PROJECT
PROPOSED RESIDENCE
AT 1 CLWYDON CLOSE
BELROSE
FOR MR & MRS BOYD

THIS DRAWING
STORMWATER
LAYOUT SH.1
BUILDER
EDEN BRAE HOMES

JOB NUMBER
E7063-20155
SHEET No. 1 of 2
REVISION 4

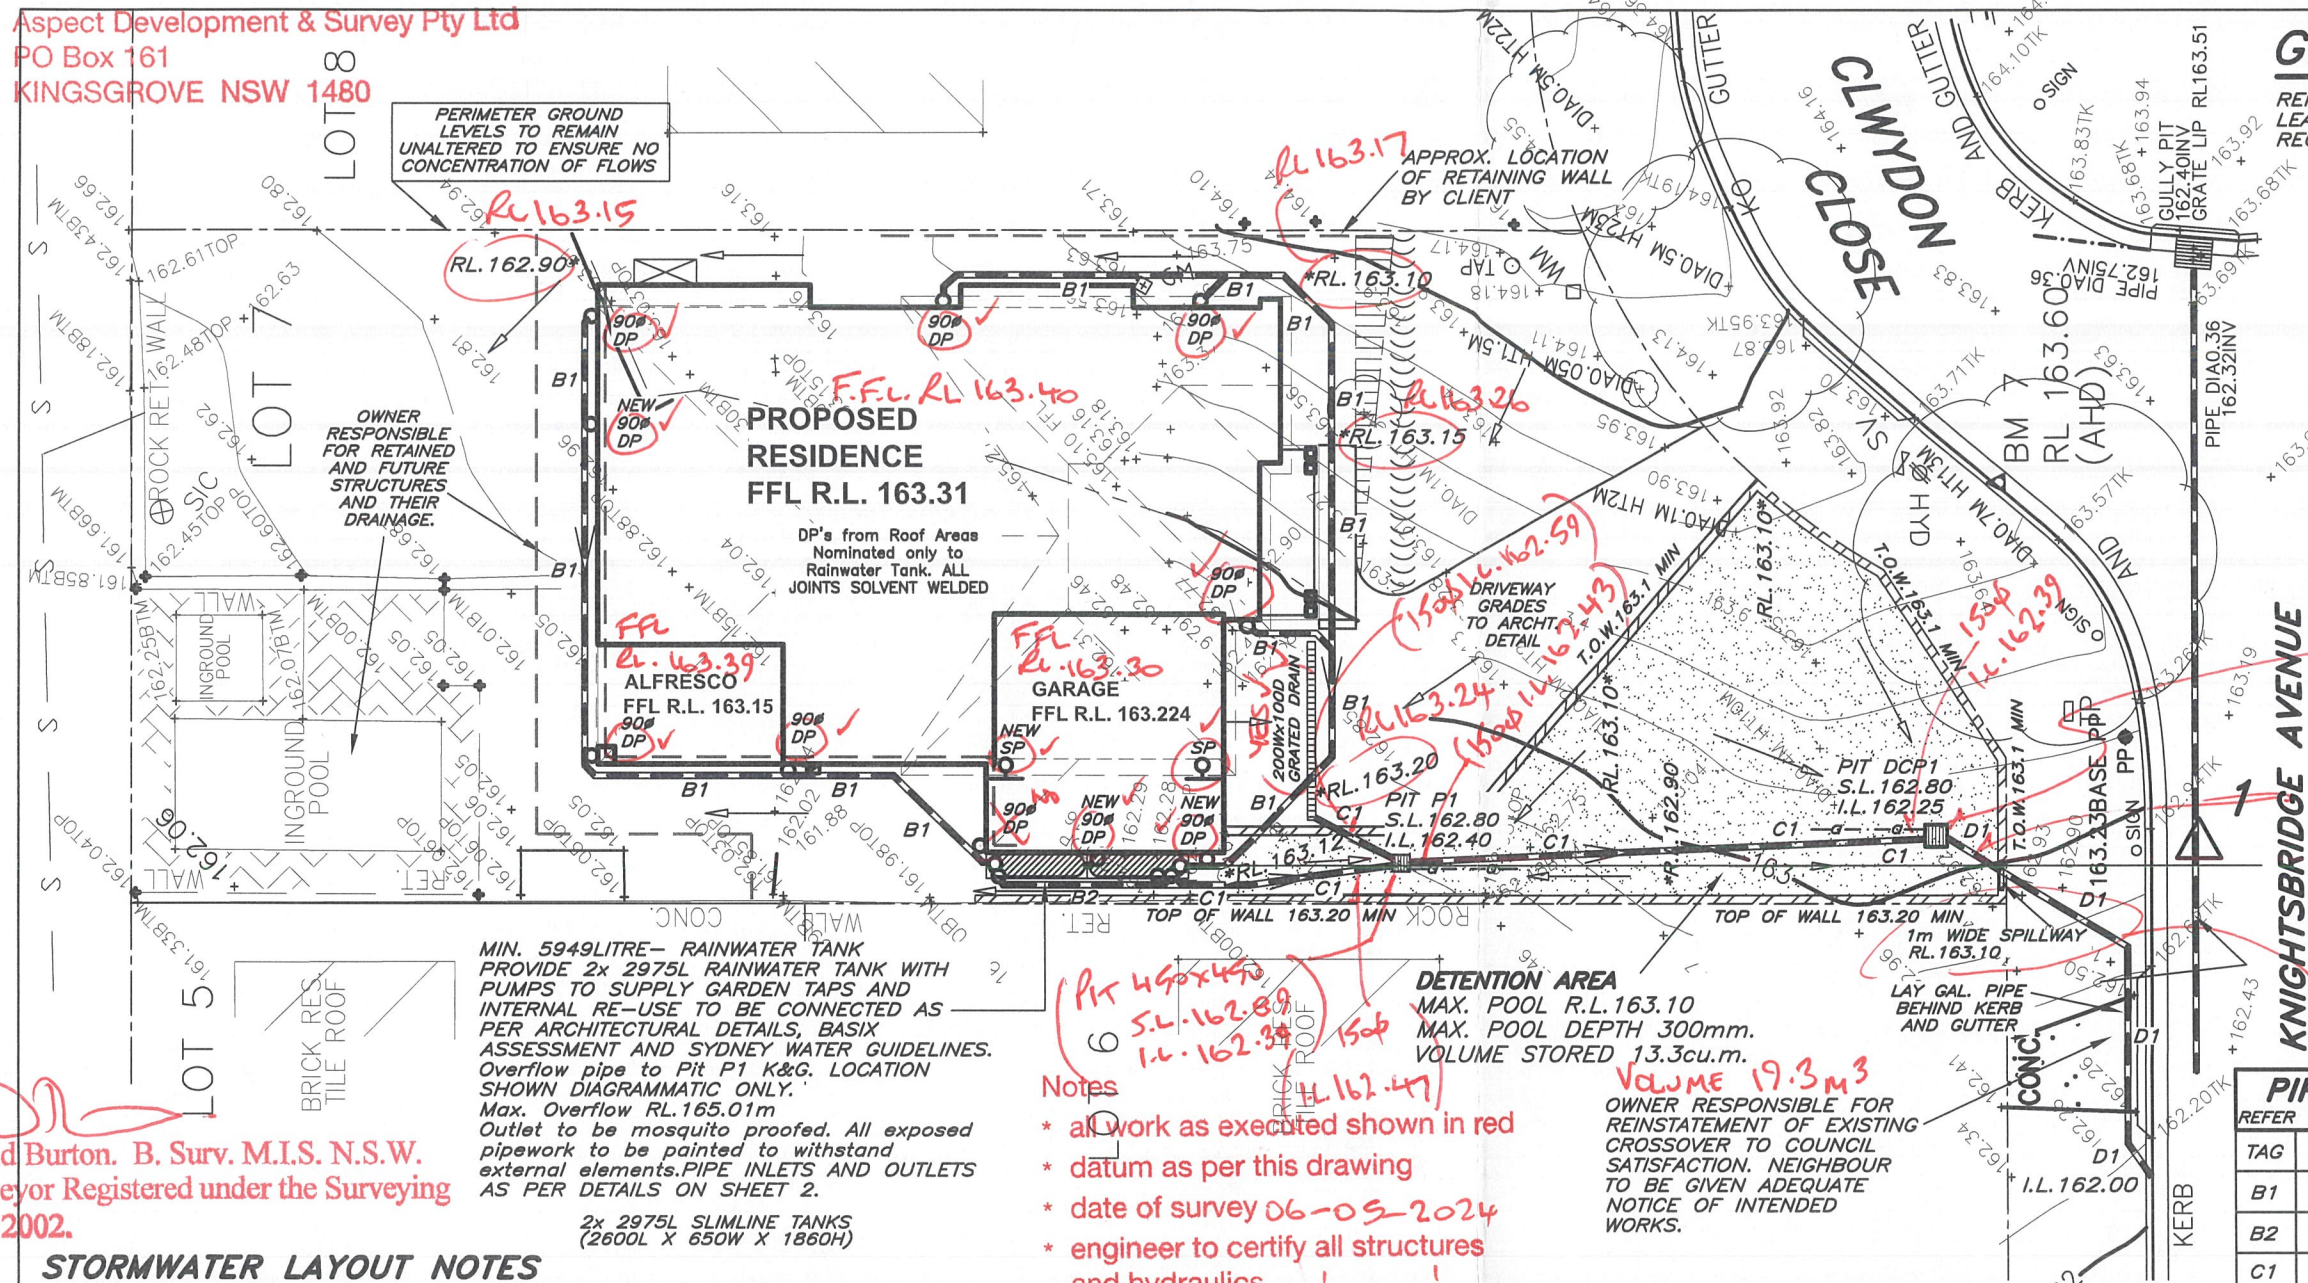
VOLUME 19.3m³
OWNER RESPONSIBLE FOR
REINSTATEMENT OF EXISTING
CROSSOVER TO COUNCIL
SATISFACTION. NEIGHBOUR
TO BE GIVEN ADEQUATE
NOTICE OF INTENDED
WORKS.

Notes
* all work as executed shown in red
* datum as per this drawing
* date of survey 06-05-2024
* engineer to certify all structures
and hydraulics
